Licence Number L5271/1983/14

Licence Holder Alcoa of Australia Ltd

Premises Pinjarra Refinery
Lot 19 on Diagram 44739, Part of Lot 109 on Diagram 60089, Part of Lot 151 on Plan 10914, Lot 221 on Plan 302632, Lot 222 on Plan 302638, Part of Lot 251 on Plan 35963 and Lot 252 on Plan 35963

Amendment Notice

Figure 6: Geological cross-section of the premises

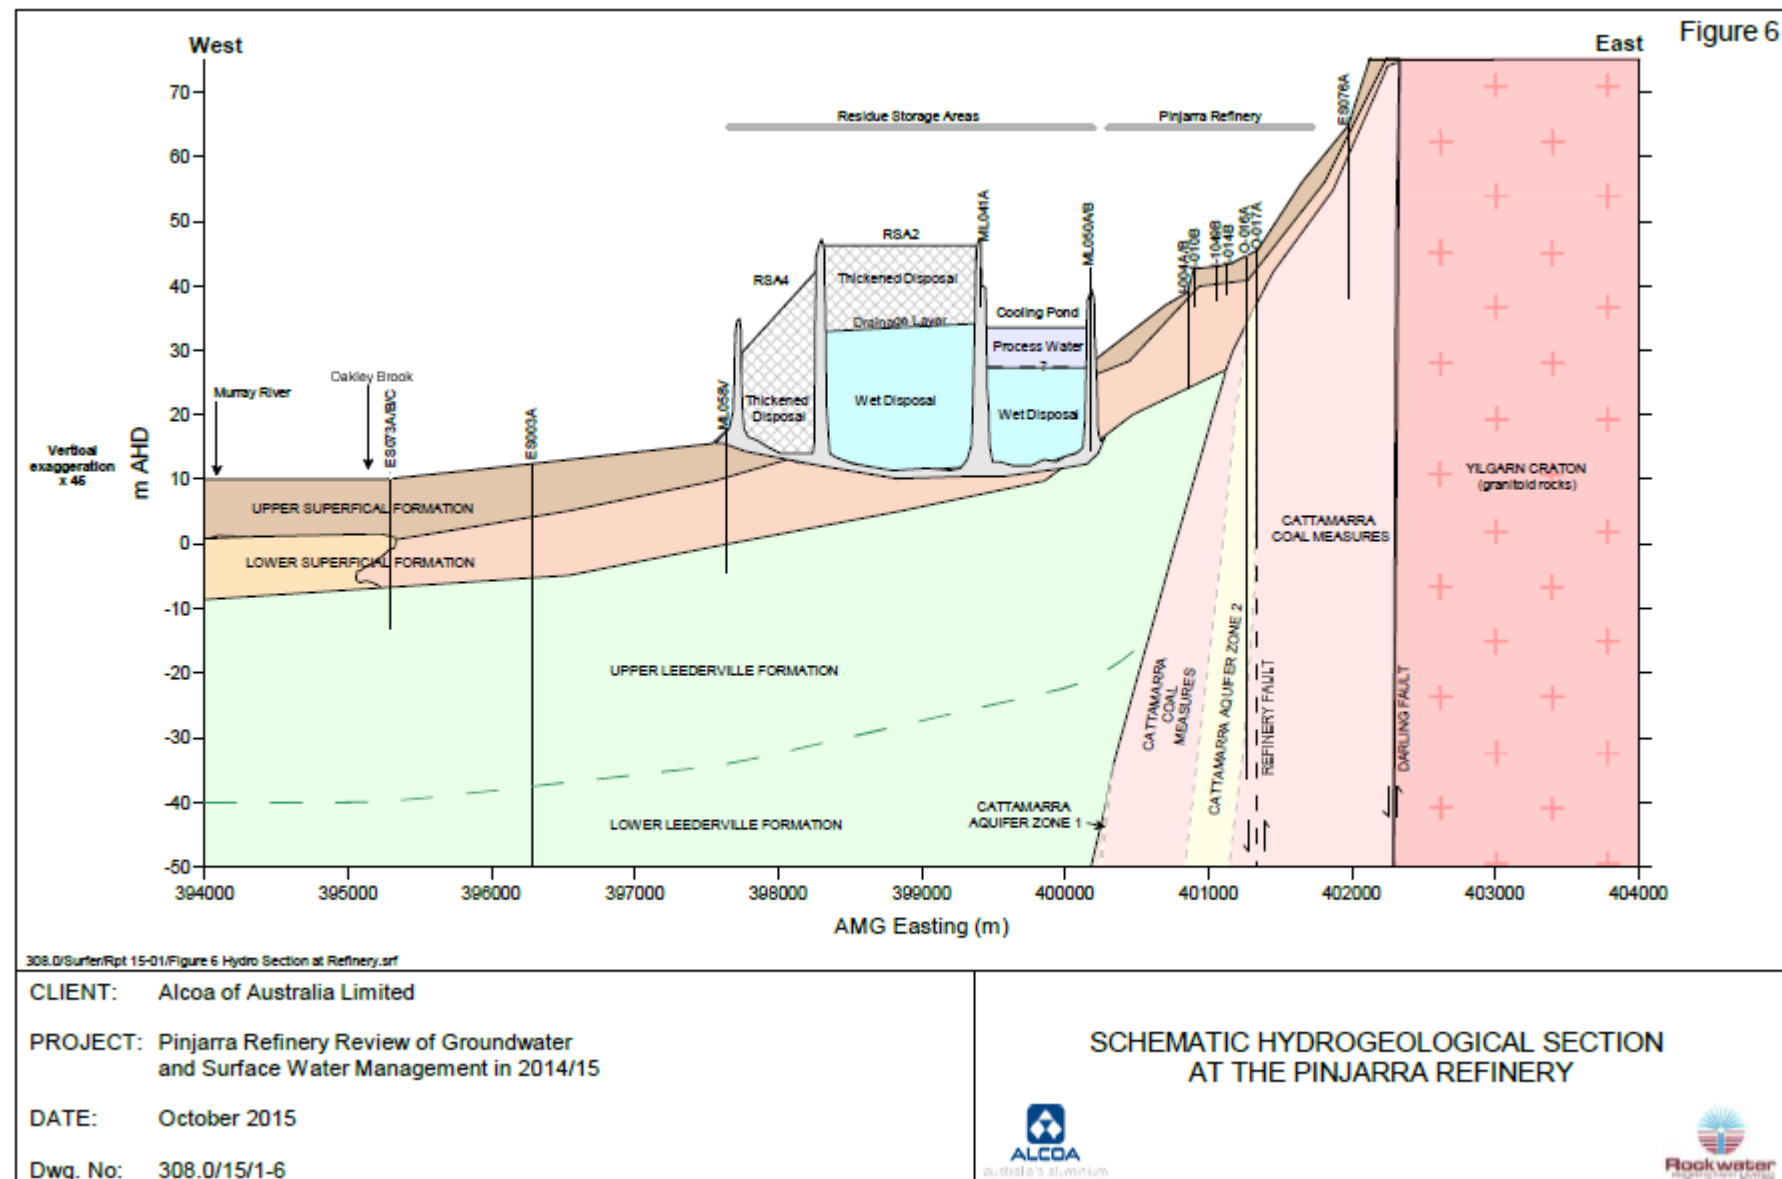
23	Location and Siting, Item 6, Pg.8	Alcoa notes that Figure 6 labelling is incorrect. What is designated in the figure as an artificial water body is the Water Corporation's Pinjarra waste water treatment plant.	<p>Figure 6 was sourced from the Licence Holder's 2012 LTRMS as referenced. The Delegated Officer is aware the artificial body is the licensed Pinjarra WWTP and did not consider the impact of surface or groundwater Risk Events on the WWTP lagoons in the assessment.</p> <p>Outcome: Text inserted to clarify that the depicted water body is the Pinjarra WWTP.</p>
